RC-2024-0122 and RC-2021-0097-V10 – DISCHARGES OF CONTAMINANTS AT TAYLORVILLE RESOURCE PARK

Further information request under section 92(1) of the Resource Management Act 1991

TO	Michael Durand	FROM	Carl Steffens
	Planz Consultants	DATE	18 December 2024
RE	Technical Review – TRPL short-term consent application to discharge contaminants to ground.

Project Name	Taylorville Resource Park		
Memo Topic	RC-2024-0122 and RC-2021-0097-V10 - RFI Response		
Memo Date	30 January 2025	Date of Site Visit	N/A
ENGEO Memo No.	08	ENGEO Project No.	26200.000.001
To	Taylorville Resource Park Limited	Copy	Barker and Associates
Author	Lyn Nugent	Reviewer	Dave Robotham

Figure A5.2 Extended Durov Class Scatter

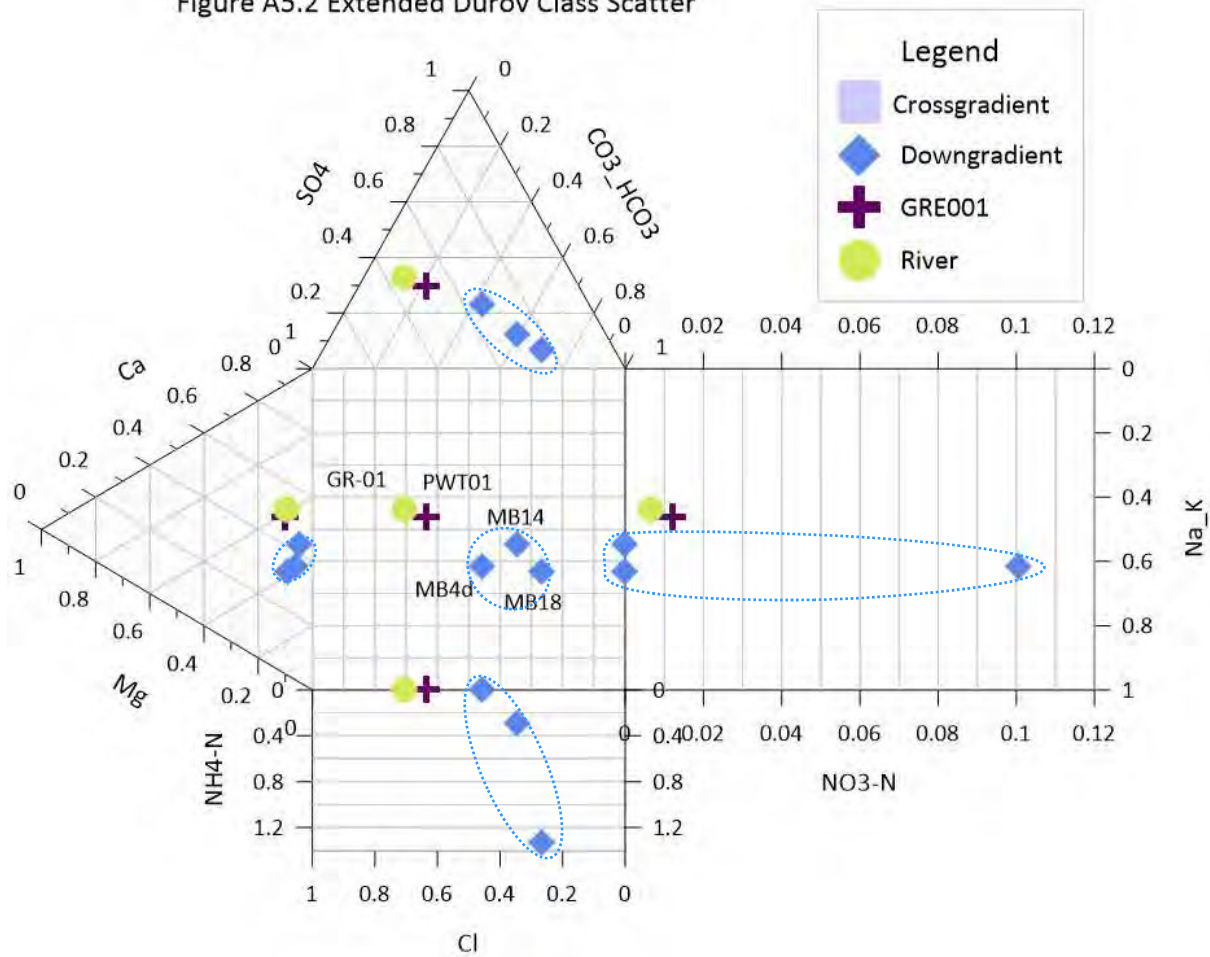
The results for ions were compared to October 2024 results from samples collected from monitoring bores MB2s, MB2d, MB3, MB4d, MB14 and MB18 and plotted on an extended Durov diagram (Figures A5.2 and A5.3 of the RFI response). These figures are shown below. ENGEO notes that bores MB2s, MB2d and MB3 are cross gradient bores, while MB4d, MB14 and MB18 are downgradient bores with respect to the waste storage areas.

As shown in Figure A5.2, the ion profile of PWT01 very closely matches that of GR-01, indicating that there is minimal input from waters downgradient of the site operations. When the samples collected from upgradient / cross-gradient wells are included (Figure A5.3) there is a greater distribution of profiles, with more similarity in anions between the upgradient / cross-gradient wells and PWT01. However, the ion profile of PWT-1 is still most closely matched to that of GR-01 and broad similarity is expected, as all samples were collected from the same catchment.

Figure 2. Map of the roadside drain and descriptive sections.

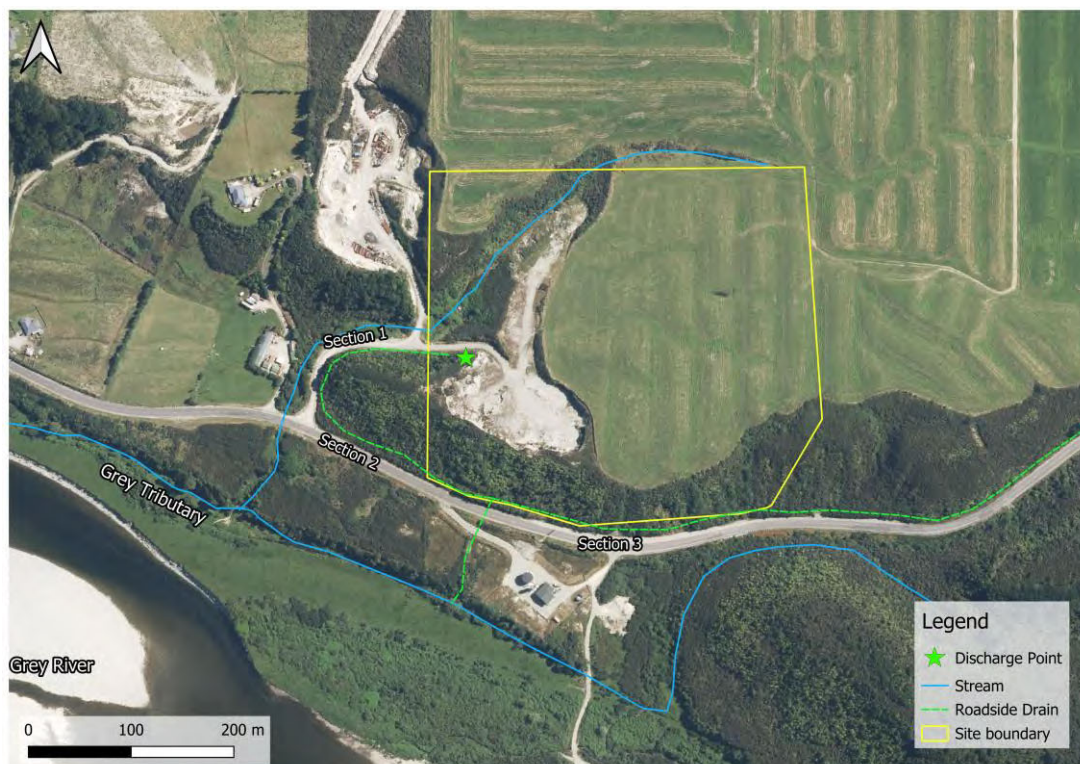
The drain, at the point of TCD1 discharge (Section 1), consists of a narrow, shallow drain within 2 m of the gravel road. The base of the drain appears to be bedrock with areas of filamentous algae and water cress (*Nasturtium officinale*) within the channel. Further downstream, where the drain runs eastwards (Section 2) adjacent to Taylorville Road, patches of budding-club rush (*Isolepis prolifera*) and duckweed (*Lemna minor*) was observed. As with Section 1, water depth was overtly shallow, and the channel is located within 2 m of the road and narrow. Section 3 of the drain, which runs westwards from the spring, is also situated close to the road, has very shallow water depth and the bed is covered in fine silts and soft sediments. Overall, the drain (Section 1, Section 2 and Section 3), contains very little hydrological heterogeneity, with shallow depth, and very little to stagnant flow.

The roadside drain receives water from multiple sources, including daylighted groundwater, overland flow paths, and surface water run-off from the surrounding landscape and roading. Water quality analysis undertaken by Engeo² show elevated levels of nitrate-N and conductivity throughout the drain, independent of the site operations.

The drain lacks complex habitats, such as woody debris, cobbles/gravels and interstitial spaces, overhanging vegetation and due to the poor water quality, the macroinvertebrate populations are expected to be of low diversity and abundance, and would consist of pollutant tolerant taxa throughout both Drain 1 and Drain 2. Barriers to fish passage are present where the drain discharges into the Grey Tributary. Native fish populations are not expected to be present in the drain.

Figure 6: Durov Plot of GRE001 Water and Upgradient Locations

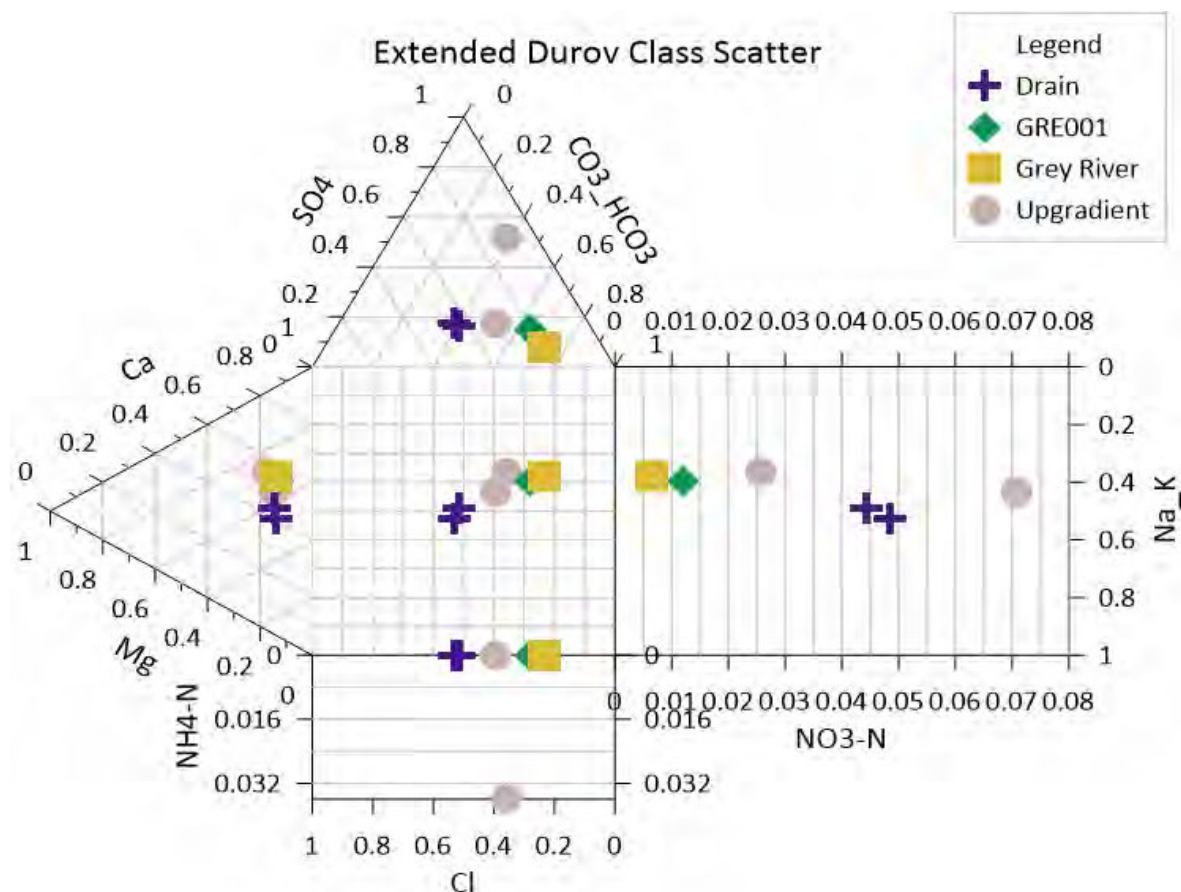
PDP notes that samples collected from TRD2 and TRD4 were not included in the comparison. We have revised our plot (Figure 6) to include only upgradient bores (MB1, MB19s), the Grey River (GR-01), untreated water for the GRE001 supply (PWT01), and the requested drain locations (TRD2 and TRD4). The drain locations were excluded from the original assessment due to the influence of other inputs along Taylorville Road and because water quality in samples collected from monitoring bores MB4, MB14, and MB18 are more relevant to assess inputs from the operations.

Figure 1. Bioresearchers Figure 1 showing an erroneous interpretation of the stream networks and locations of sampling sites that were not subsequently reported.

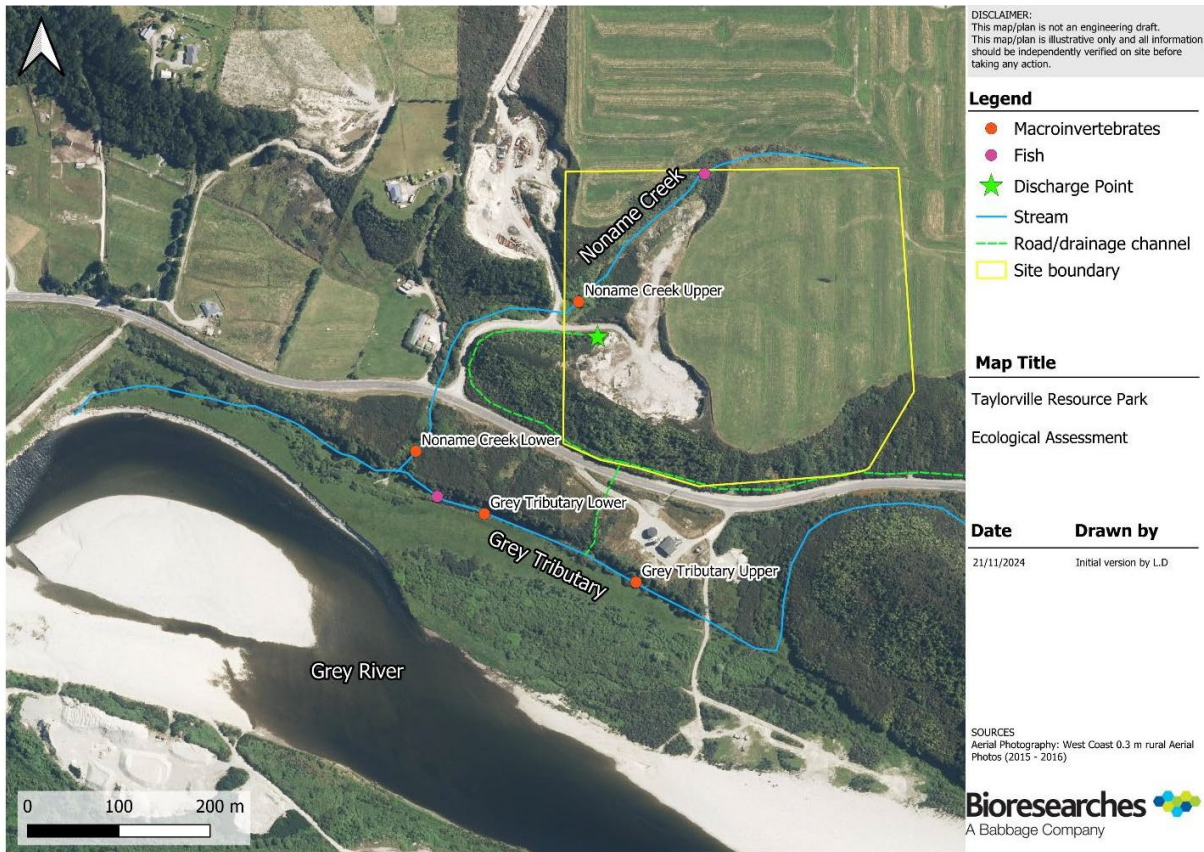
The Bioresearches EcIA is a brief document based on a walk-over or images provided by a third party. It is not apparent that Bioresearches visited the site or what assessments were undertaken. Bioresearches Figure 1 (provided below) indicates that macroinvertebrates and fish were surveyed, but that information is not presented in the document. Throughout there are statements made about values that have little to no basis or supporting material and are counter to my own interpretations of the information provided.

I note that the alignment of streams shown by Bioresearches (Figure 1) is incorrect and I have included what appears to be a correct interpretation of waterways presented in an EHS Support report from 2024 (this document Figure 2).

Based on the descriptions provided above, we note that Bioresearches Figure 1 indicates that the Noname Creek 2 and the Grey River tributary are connected and the lower section of the Noname Creek 2 on the Grey River floodplain are also not shown in the Bioresearches figure. In addition, the Bioresearches figure doesn't show the culverts at the locations of TRD2 and TRD4 that provide a pathway for drain water on the northern side of Taylorville Road to enter into the Noname Creek 2.

Figure 3. Location of proposed discharge of excess leachate and stormwater to land and inferred range of potential groundwater flowpath (ENGEO preliminary hydrogeological investigation).

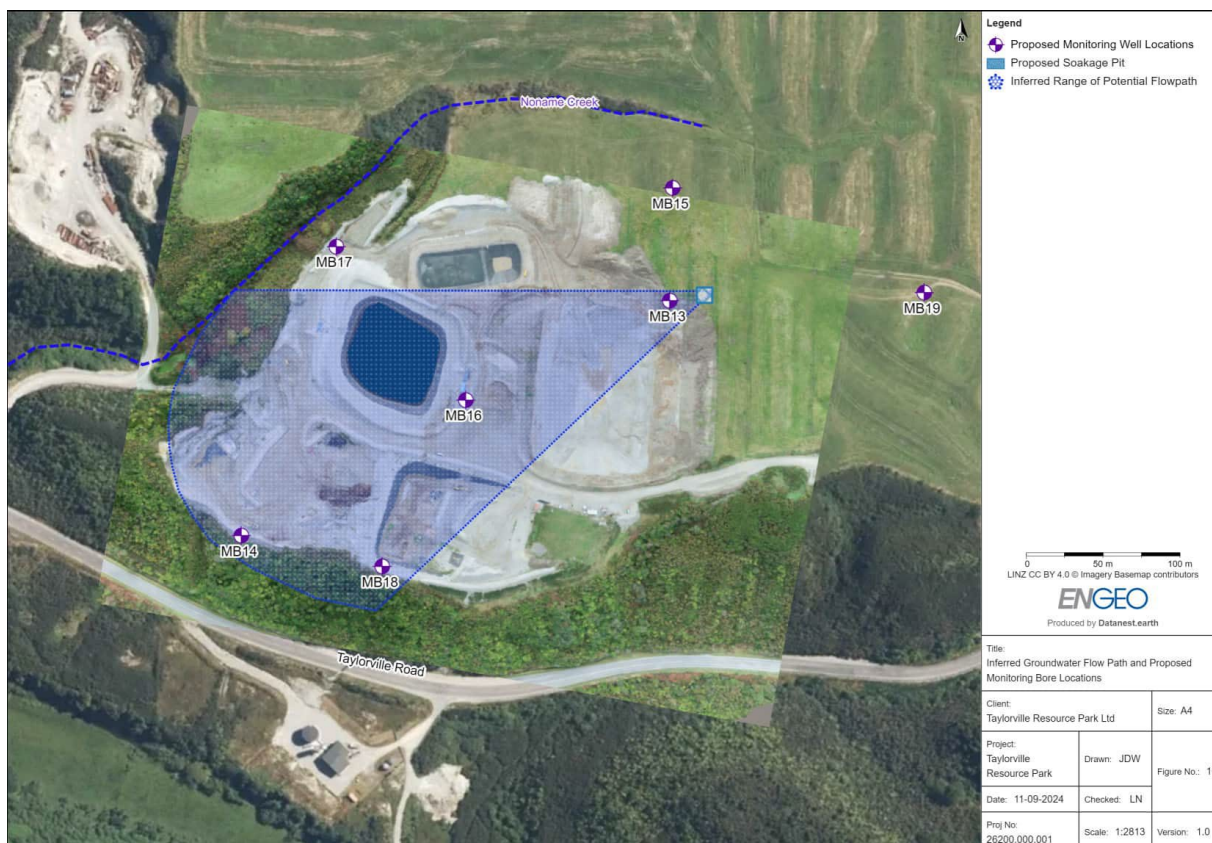
It is not clear from the EcIA undertaken by Bioresarches what their understanding of the potential flow paths of leachate and stormwater to the receiving environment might be. The map included in the assessment shows a discharge point at the head of the roadside drain immediately west of the landfill (corresponding with the known spring location), however ENGEO confirm the location of the proposed discharge to land is east of the landfill as shown above in Figure 3 of this memo.

My understanding based on discussion with Carl Steffens is that contaminated water potentially being discharged to land at the location shown in Figure 3 will likely cause significant mounding of groundwater beneath the point of discharge, potentially causing a local increase in groundwater level by up to 8 m (groundwater may reach near the ground surface at the discharge point). This will affect local groundwater flow directions with potential local groundwater flow from the discharge point occurring radially in all directions. This could cause local migration of contaminants in the discharge in a northerly direction toward the upper reaches of Noname Creek, as well as in the natural direction of groundwater flow (generally from west through to south) and also to the south-east. Therefore, PDP's view is that the inferred contaminant flow path indicated by ENGEO and which is shown in Figure 3 may not be accurate.
